4. Rezoning Application No. 00489 for 2035 Stanley Avenue (Fernwood)

6.2. a. and b. Rezoning Application No. 00489 for 2035 Stanley Avenue and Development Permit with Variances Application No. 00489 for 2035 Stanley Avenue (Fernwood)

Committee of the Whole Report

Subject: Rezoning Application No. 00489 for 2035 Stanley Avenue

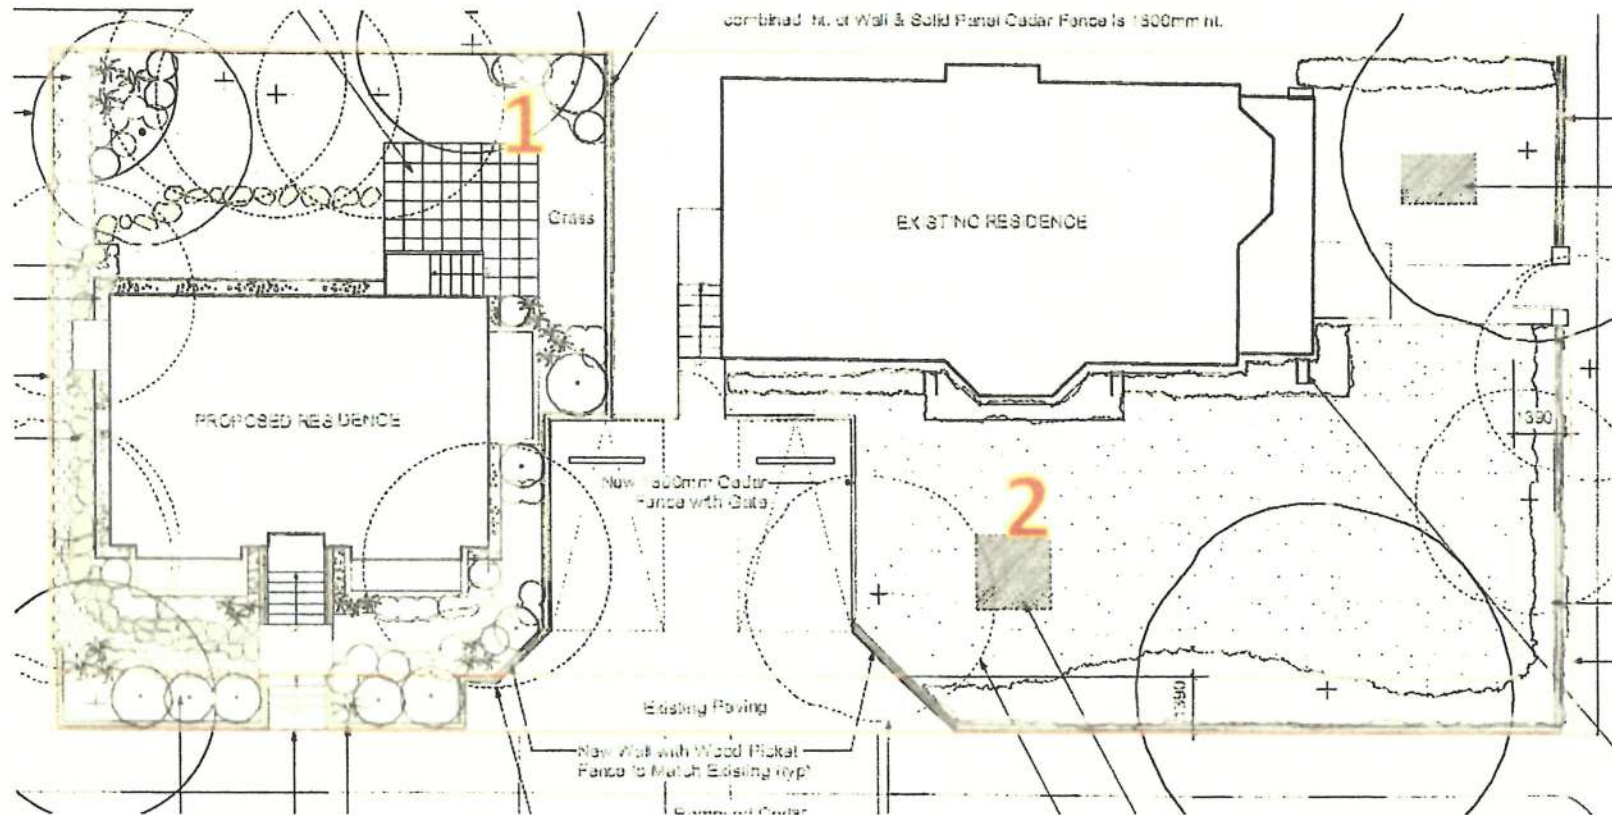
This Site Plan (#1) shows the separation between the houses as more of a side yard arrangement, with the existing residence enjoying a large outdoor space in the northeast of the property (#2)

Title:
LOT 2
FLOOR PLANS &
ELEVATIONS

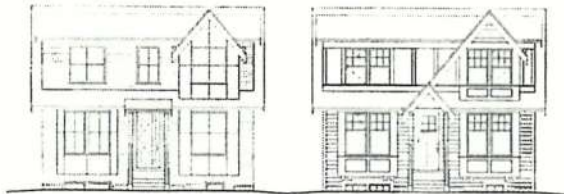
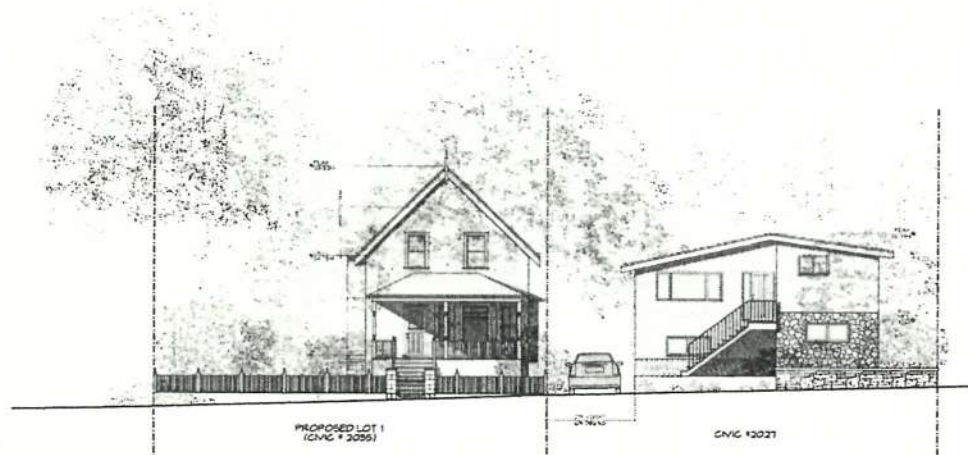
REVISED ELEVATION

PREVIOUS ELEVATION

REV. NO.	DESCRIPTION	DATE	REVISION	SHEET
2	AWAYING REAR SIDE ELEVATION CHANGES TO TOP ENDING WALLS ELEVATION TREE REMOVED FOR REFLECT INTERIOR DESIGN FINISHES REVEALED ROOF PLAN RE-DESIGNED TO MATCH CHANGES TO ROOF LINE	AUG 2015	11 MAR 14/15 12 MAR 2015	SK 2.1 Proj No 100
